•			
APPLICATION NO.	FILING DATE	FIRST NAMED INVENTOR	ATTORNEY DOCKET NO.	CONFIRMATION NO.
10/720,821	11/24/2003	Douglas B. Wilson	114089.120 5355	
23483 WILMEDHAL	7590 11/26/2007 F/ROSTON		EXAMINER	
WILMERHALE/BOSTON 60 STATE STREET BOSTON, MA 02109			LUONG, VINH	
			ART UNIT	PAPER NUMBER
			3682	
		•		
			NOTIFICATION DATE	DELIVERY MODE
			11/26/2007	ELECTRONIC

· · · · · · · · · · · · · · · · · · ·	Application No.	Applicant(s)			
,) -	Application No.				
	10/720,821	WILSON, DOUGLAS B.			
Office Action Summary	Examiner	Art Unit			
	Vinh T. Luong	3682			
The MAILING DATE of this communication app Period for Reply	ears on the cover sheet with the o	correspondence address			
A SHORTENED STATUTORY PERIOD FOR REPLY WHICHEVER IS LONGER, FROM THE MAILING DATE - Extensions of time may be available under the provisions of 37 CFR 1.13 after SIX (6) MONTHS from the mailing date of this communication. If NO period for reply is specified above, the maximum statutory period was reply received by the Office later than three months after the mailing earned patent term adjustment. See 37 CFR 1.704(b).	ATE OF THIS COMMUNICATION 36(a). In no event, however, may a reply be tir vill apply and will ex

ATTACHMENT 1

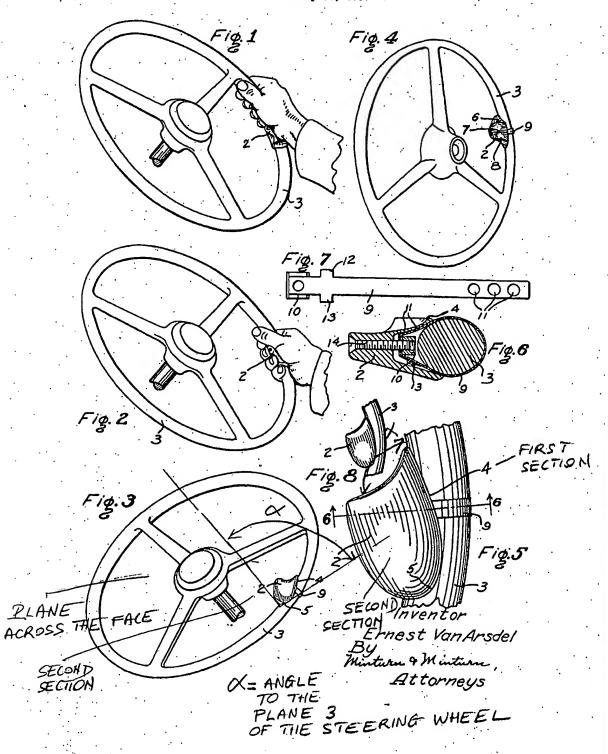
Regarding claim 20, Van Arsdel teaches a fatigue relieving/preventing apparatus associated with a steering wheel 3 for controlling a vehicle comprising:

a first section 4 (i.e., horizontal section in Fig. 3) that connects to a peripheral portion 3 of the steering wheel 3; and

a second section 2 (*i.e.*, a concave upward section in Figs. 3 and 5) that connects to and extends from the first section 4 at the peripheral portion 3 of the steering wheel 3, the second section 2 extends from the first section 4 outward at an angle (see angle α in Figs. 3 and 5 of the Attachment 1) to a plane (Att. 1) across a face to the steering wheel 3, with the second section 2 inherently for supporting at least a portion of a vehicular operator's body (e.g., the hand as seen in Figs. 1 and 2) when pressure from the portion of the vehicular operator's body on the second section 2 is less than the pressure for deforming the second section 2 out of interference with the vehicular operator's ability to operate the steering wheel 3, and deforming out of

interference with the vehicular operator's ability to operate the steering wheel when pressure from the portion of the vehicular operator's body on the second section is equal to or greater than the pressure for deforming the second section out of interference with the vehicular operator's ability to operate the steering wheel 3. *Ibid.* right column on page 1, lines 29-54.

In the case at hand, on page 1, right column, lines 13-28, Arsdel describes: "[t]he grip rest 2 is concave longitudinally and about half of the rest extends over and part way across the steering wheel rim 3 in a manner to slope downwardly and inwardly of the rim. The outer edge 4 of the side, and 5 of the rear end of the concave, located above the rim, extends up into a marginal flange to be contacted by the inside of the ball of the thumb or by the bottom of the hand, depending upon which part of the hand is seated to rest." See also Arsdel's claims 1 and 2. Arsdel's concave upward section 2 extends from the first section 4 outward at an angle a to the plane across the face of the steering wheel as seen in Figs. 3 and 8 of Attachment 1. Therefore,

Arsdel's concave upward section 2 in Fig. 3 of Arsdel "reads on" Applicant's claimed second section.

Simply put, Arsdel explicitly teaches that the driver may loosen the screw 14 in Fig. 6 so that it is *deformable* in order that the driver can put extensive pressure on it and *it will move* for steering the automobile.

The support in the description of Arsdel that it will deform out of the interference with the operation of the steering wheel is on page 2, left column, lines 28-32. By loosening or reversing the screw 14 sufficiently to permit Arsdel's second section 2 shifted or vertically around the rim 3, the second section can be at the new position wherein the second section does not interfere with the operation of the steering wheel to suit the requirements or fancy of the driver.

ATTACHMENT 2

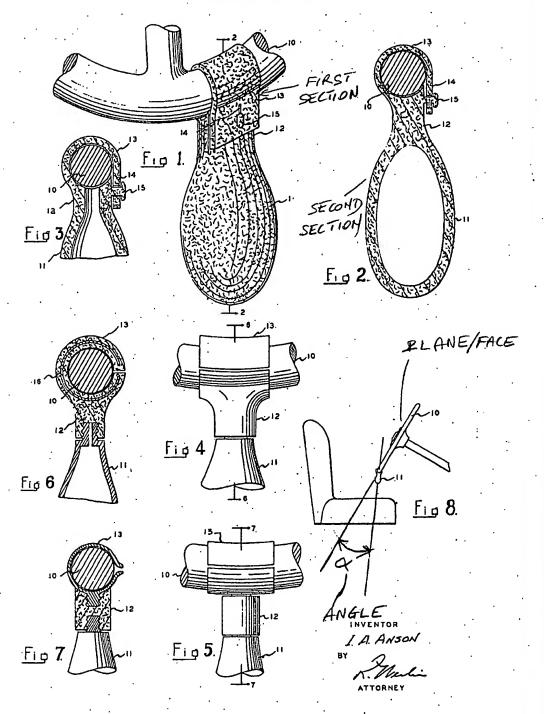
Regarding claim 20, Anson teaches a fatigue relieving/preventing apparatus associated with a steering wheel 10 for controlling a vehicle comprising:

a first section 13 that connects to a peripheral portion of the steering wheel 10; a second section 11 extends from the first section at the peripheral portion of the steering wheel 10, the second section 11 extends from the first section 13 outward at an angle (see angle α in Fig. 8 of Attachment 2) to a plane (Att. 2) across a face (Att. 2) to the steering wheel 3, the second section 11 inherently for supporting at least a portion of a vehicular operator's body (e.g., the hand) when pressure from the portion of the vehicular operator's body on the second section 11 is less than the pressure for deforming the second section 11 out of interference with the vehicular operator's ability to operate the steering wheel 10, and deforming out of interference with the vehicular operator's ability to operate the steering wheel 10 when pressure from the portion of the vehicular operator's body on the second section 11 is equal to or greater than the pressure for deforming the second section 11 out of interference with the vehicular operator's ability to operate the steering wheel 10.

Regarding claim 21, the second section 11 is deformable in at least one direction when deforming pressure is applied to such second section 11 since it is made of a flexible material such as rubber. *Ibid.* right column on page 1, lines 46-53. On the other hand, note that virtually anything will be deformed if enough pressure is applied to it. See the term "flexible" in *Fredman v. Harris-Hub Co., Inc., supra.*

The instant assertion is likewise unsupported by substantial evidence in the record. In fact, Anson's grip is made of flexible or semi-rigid material, therefore, Anson's grip is deformable or deflectable out of interference with the vehicular operator's ability to operate the steering wheel, *i.e.*, out of the normal position. See page 2, right column, lines 25-40, quoted below:

As evidenced in the above quotation, Anson explicitly states that the driver may rotate Anson's attachment/handgrip about the wheel rim 10 to a position within the periphery of the wheel, *i.e.*, to a position shown in Applicant's Fig. 4 when the driver so desires. Anson's description above reveals that Anson-type-attachment is operated in a similar manner to what is claimed in claim 20. As such, a person of ordinary skill in the art would find that there is a teaching in Anson in which the hands are or other body part is supported by Anson attachment as set forth in claim 20.

Further, since Anson's attachment may be rotated about the wheel rim from its normal pendent position to a position within the periphery of the wheel when it becomes desirable to dispense with its use in operating the wheel, Anson's attachment is capable to be rotated outward such that the second section 11 is at an angle from the plane across the face of the steering wheel and out of interference with the operation of the steering wheel as claimed. On the other hand, it is well settled that a claim containing a "recitation with respect to the manner in which a claimed apparatus is intended to be employed does not differentiate the claimed apparatus from a prior art apparatus" if the prior art apparatus teaches all the structural limitations of the claim. Ex parte Masham, 2 USPQ2d 1647 (BPAI 1987) and MPEP 2114.
